Project	IEEE 802.16 Broadband Wireless Access Working Group < http://ieee802.org/16 >	
Title	TG3 Channel Model – Protested Status and Voting	
Date Submitted	2001-07-02	
Source(s)	David Trinkwon Transcomm Inc PO Box 2886, Fairfax Virginia, 22031	Voice: 650 245 5650 Fax: 650 649 2728 trinkwon@compuserve.com
Re:	Status of Document 802.16.3c-01/29r1 and subsequent Motions / Voting at Meeting #13 (Orlando)	
Abstract	This document records the misunderstandings that were revealed at Meeting #13 (Orlando) regarding the status and disposition of the TG3 Channel Model document 802.16.3c-01/29r1 at Meetings #11 (Ottawa) and #12 (Hilton Head) and its relevance for subsequent voting at Meeting #13 (Orlando). Conclusions are made which would alter certain decisions of the Chair on these matters at Meeting #13. Some commentary is also provided as to why the resolution of these misunderstandings is important to the integrity of the proposed 802.16a Standard.

TG3 Channel Model – Protested Status and Voting

DRAFT 802.16.3/29r2 PRESENTED AT MEETING #12 (Hilton Head)

Channel Models for Fixed Wireless Applications

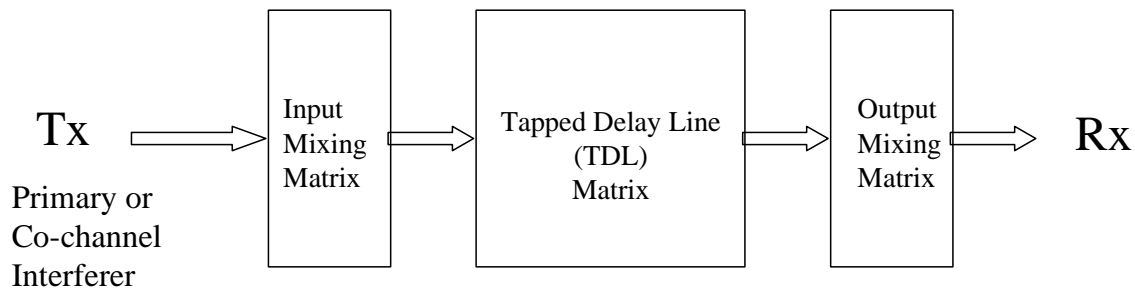
Proposed Changes (Multipath Taps)

- a) Need to increase the number of multipath taps from 3 to 5,6 or 7 (without changing the delay spread)
- b) Replace scattering part of main (first) tap with exponential decay ($t_c=100-200\text{ns}$) to better model local reflections near the receiver
- c) Need Monte Carlo modeling for the placement of taps within the delay spread. Current taps are too regular.
